**RE: 2020 Annual Geotechnical Inspection – Lupin Mine Tailings Containment Area, Nunavut  
Lupin Mine, Nunavut, License Number 2AM-LUP2032**

## **2020 Lupin Mine Tailings Area Inspection Report**

Annual Geotechnical Inspection of the  
Tailings Containment Area

December 18, 2020

Photo 32: Looking east at the reinforcement buttress being constructed eroded toe at Dam K.

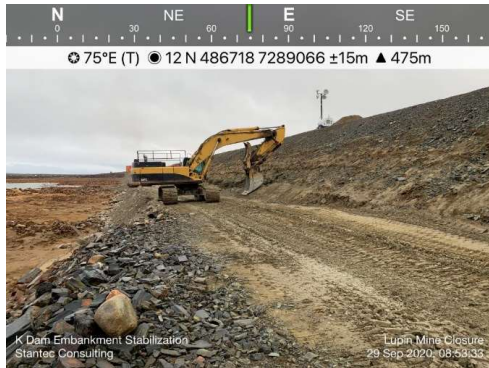
Dam K has experienced considerable undercutting at the toe from Pond 2 wave action that was reported previously, and it was repaired this year. Construction was conducted as the Pond 2 water level was lowered to allow stable access to the toe of the dam. A buttress was constructed with compacted sand and gravel to reinforce the toe and support the face of the dam. The buttress was constructed to approximately half the height of the dam with a 5m crest. The construction work was overseen by a designated EOR representative to ensure the buttress was constructed using appropriate material and compacted accordingly.

Photo 46: Looking down at the incident on the Dam M buttress where localized failure caused by the equipment, near the junction of Dam N.

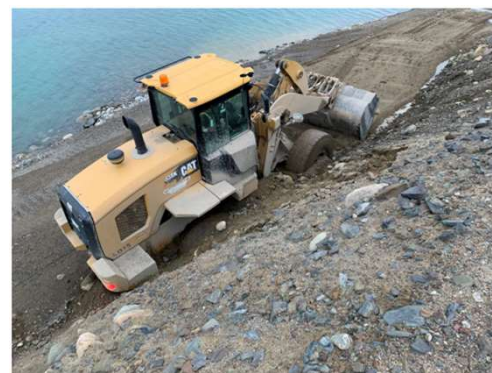
Dam M	2.2	Sloughing in localized sections of the buttress due to raised water level during 2020 freshet. A construction incident has caused a localized minor failure to the downstream face of the dam.	Repair the sloughed section of the buttress and the localized failed section once the water level is lowered. Re-slope the buttress to 2H:1V design for final closure.	Minor erosion at the downstream toe above the riprap protection	Repair the eroded toe areas.
Dam N	0.8 <sup>(2)</sup>	A shallow channel was constructed to manage 2020 freshet. It was backfilled under engineering oversight. Material was stockpiled on the dam in preparation for cover placement.	Monitor the water level behind Dam N and lower the water when practicable to yield minimum 1m freeboard. Monitor the dam around the stockpile for deformation.	Minor wave action erosion at HWM.	Monitor the water level behind Dam N and lower the water when practicable to yield minimum 1m freeboard.

1. Upon recommencement of closure activities in 2021, the localized failed section of Dam M should be repaired.
2. Monitor the seepage at the downstream toe of the divider dyke for erosion and potential instability. Repair as needed in 2021 when access is available.
3. Monitor the proximity of the breached location in Dam L for any seepage and potential instability. Repair as needed in 2021 when access is available.
4. Monitor the water level behind Dam N and lower the water level to maintain a minimum 1m freeboard.

1. Upon recommencement of closure activities in 2021, the localized failed section of Dam M should be repaired. LMI will also be carrying out the closure work as per the construction drawings filed with the NWB in July 2020 under Part G, Item 1.
2. Monitor the seepage at the downstream toe of the divider dyke for erosion and potential instability. Repair as needed in 2021 when access is available.
3. Monitor the proximity of the breached location in Dam L for any seepage and potential instability. Repair as needed in 2021 when access is available.
4. Monitor the water level behind Dam N and lower the water level to maintain a minimum 1m freeboard.

Photo 51: Looking north at the downstream slope and the seepage zones at the toe of the divider dyke.

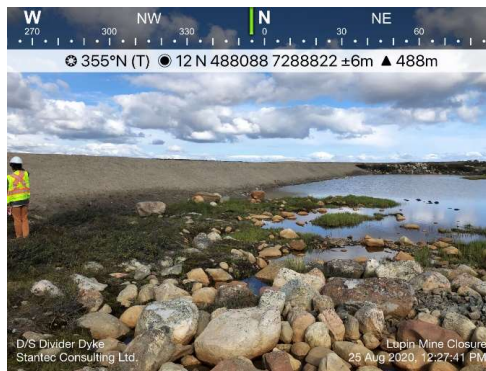
The cracks and erosion observed in the divider dyke were repaired by the newly placed compacted fill. However, new zones of seepage were observed at the newly constructed downstream toe of the divider dyke. These seepages were not observed previously and were monitored during closure activities. The seepages will continue to be monitored until the proposed spillway is constructed in 2021. The seepages are expected to stop once the spillway is constructed to passively manage the water at the closure elevation, which is below the observed seepage zones.

Divider Dykes	1.7	The dam was raised by 0.8m temporary to manage freshet. The old erosion and crest were repaired. New seepages are	Continue to monitor the seepages until the closure spillway is constructed. Repair any erosion	Erosion, sloughing and cracks along upstream and downstream of the northern portion of the dyke. Uneven	Second priority to complete the repair to the northern section
